Technical Service Information

FORD AODE/4R70W CONVERTER CLUTCH SHUDDER

**FORD A0DE/4R70W
TCC SHUDDER**

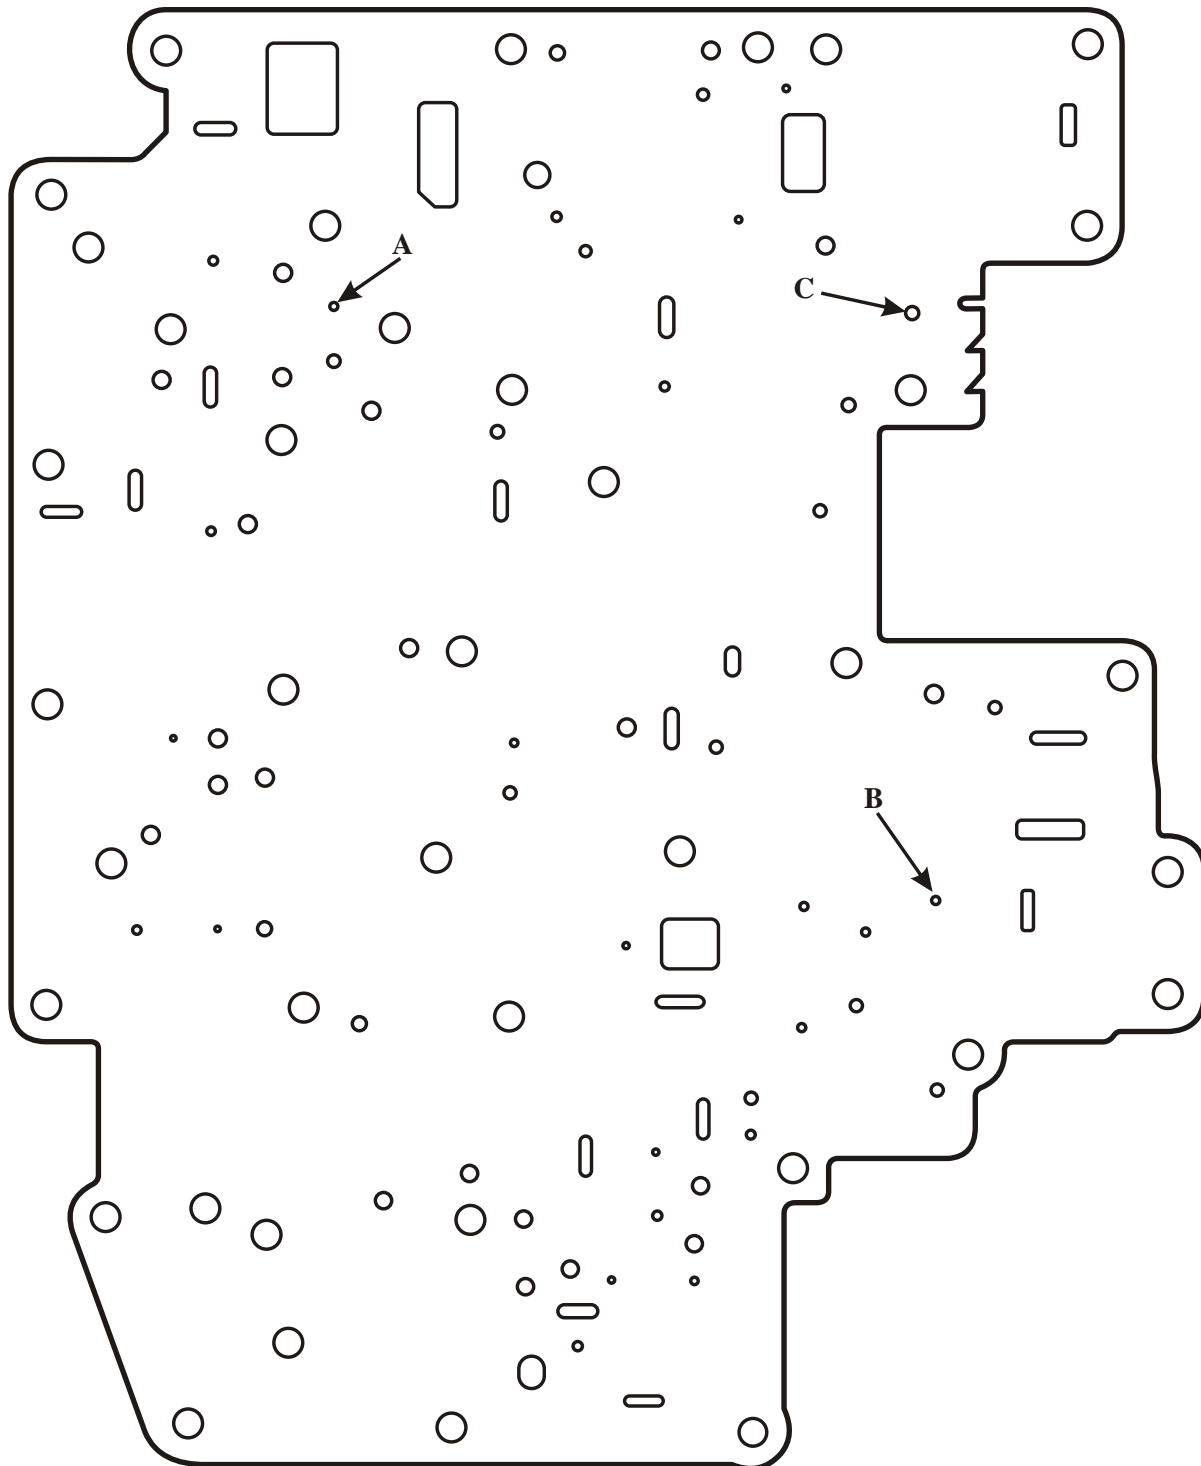
COMPLAINT: Before and/or after rebuild, the vehicle exhibits a converter clutch shudder condition, even with the proper Mercon® transmission fluid installed.

CAUSE: The cause may be, not enough oil to the converter clutch apply circuit.

CORRECTION: Drill the hole marked "A" in Figure 1 out to .062", which increases the volume of oil to the bypass clutch control valve apply circuit.

Drill the hole marked "B" in Figure 1 out to .062", which increases oil volume to the MCC/PWM solenoid. This increased oil to the valve's apply circuit ("A" orifice).

Restrict the hole marked "C" in Figure 1, to approximately .030" using a cotter key, which ensures that apply oil can overcome this balance circuit.

1. DRILL HOLE MARKED "A" OUT TO .062".
2. DRILL HOLE MARKED "B" OUT TO .062".
3. INSTALL COTTER PIN IN HOLE MARKED "C"
TO REDUCE SIZE TO APPROXIMATELY .030".
